Environmental and Ecological Planning Advisory Committee

The 5th Report of the Environmental and Ecological Planning Advisory Committee

April 19, 2018, 5:00 PM

Dillon, 2018

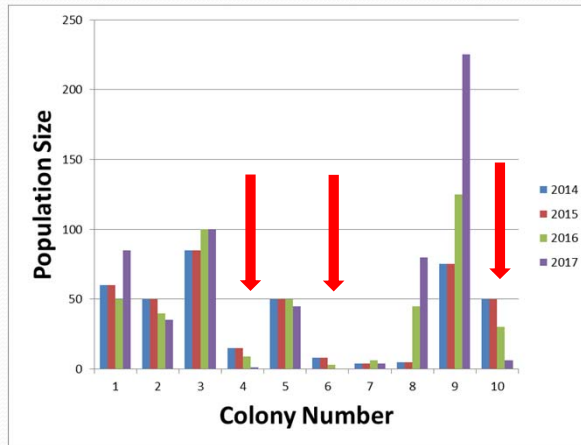
- Photographs (Dillon 2015, 2016, 2018) indicate an initial reduction in goutweed; the 2017 photos indicate an increase from 2016
- The effects of restoration on False Rue-anemone are uncertain because acceptable limits and targeted outcomes, as well as measurements to determine these, were not clearly described before the action.
